**Veterans
Administration**

SUBJ: Addendum to Amendment #37 to NRC Biproduct Material License #04-01935-03.

AIR OUTLET TEST REPORT

PROJECT Vet Admin Hosp - Nuclear Med SYSTEM EXIST SYSTEMS

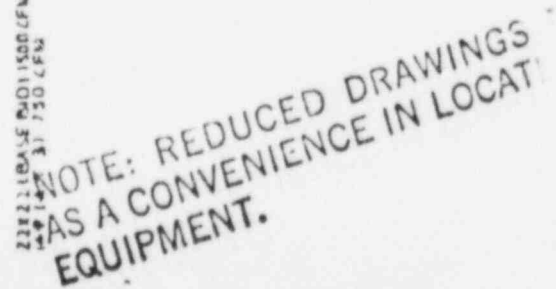
• It is not clear where the exhaust + return air vents move the air.

• What areas are described? What are the areas used for? Rooms E306, E308, E310, ~~E312~~ E312, and E314 are shown on the diagram. Uses as noted below:

- Why did you refer to the August 15, 1983 submittal?
They are using the same number of patients, the same doses, and the same number of views per patient.
- Mr. Holmes will submit further information on air flow. He will show the calculations which verify that the unrestricted ~~area~~ area air concentration limits are met within the nuclear medicine area.

This letter is an addendum to the request for amendment #37 on July 17, 1985, Item No. 5: The differential ventilation rate is -820 cfm (not -380 cfm). This -820 cfm value is found by (1) identifying the supply vents A, B, E, H, K, M, N (see identification sheet and map - attached, obtained from VA Engineering Service), (2) measuring their linear flow rates, (3) calculating the volume flow rates by multiplying the linear flow rates by the respective vent area (see previously submitted Vent Air Flow Rates), (4) summing the supply vent volume flow rate values and (5) subtracting the full open hood volume flow rate from that sum. This results in the differential ventilation rate of $80 + 100 + 220 + 90 + 105 + 100 + 90 = 1605$ equals -820 cfm. This improved ventilation rate differs from the -380 cfm value quoted in the letter of 7/17/85 because vents C and D were mistaken as supply vents while they are vents for internally recirculated (cooled) air. CONCLUSION: Negative air pressure occurs within the Nuclear Medicine facility due to the negative air ventilation rate produced by the hood at full open position.

Mr. Holmes stated that there is a self-contained air conditioner for the nuclear medicine facility. He will submit more information describing the air flow.
